**City of Framingham**  
**Fuller Middle School**  
**Preferred Schematic Report**  
**MSBA Review Comment Responses**  
**10/18/18**

**ATTACHMENT A**  
**MODULE 4 – SCHEMATIC DESIGN REVIEW COMMENTS**

## TECH MAKER SPACE

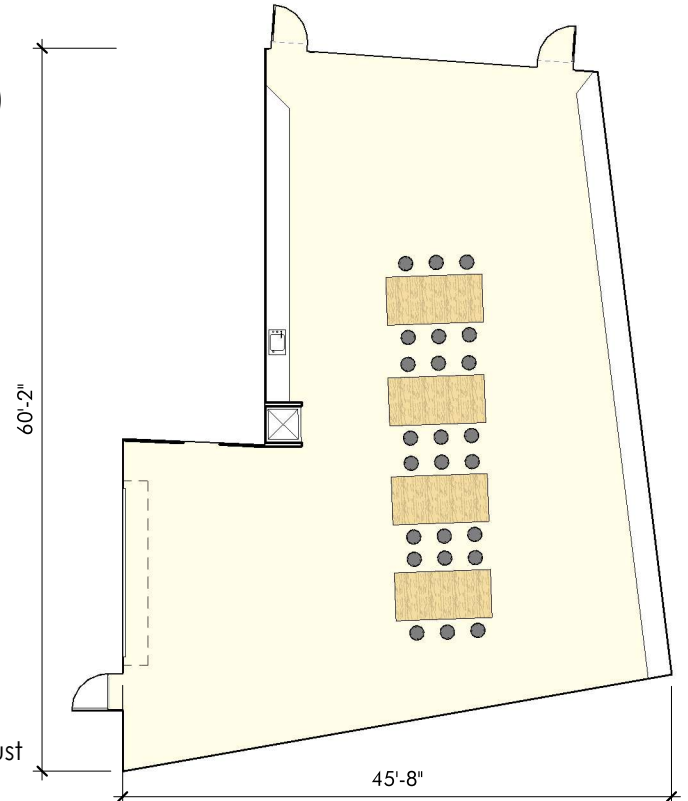
*13) The educational program provided indicates the makerspace and fabrication labs will be provided with both woodworking and metalworking equipment, 3-D printing, laser cutting machines, and overhead electric power drops. In response to these review comments, provide updated room data sheets that include all safety features associated with these technology spaces, including but not limited to; fire protection, emergency eyewash stations, instructor water controls, and automatic shutoff switches to specialized equipment. Additionally, please confirm that adequate ventilation has been provided for all specialized equipment including 3-D printers.*

Response: Confirmed. Please see revised room data sheets attached.

Safety Features: fire protection, emergency eyewash station, instructor water controls, and automatic shutoff switches to specialized equipment. Adequate ventilation shall provided for all specialized equipment including 3-D printers.
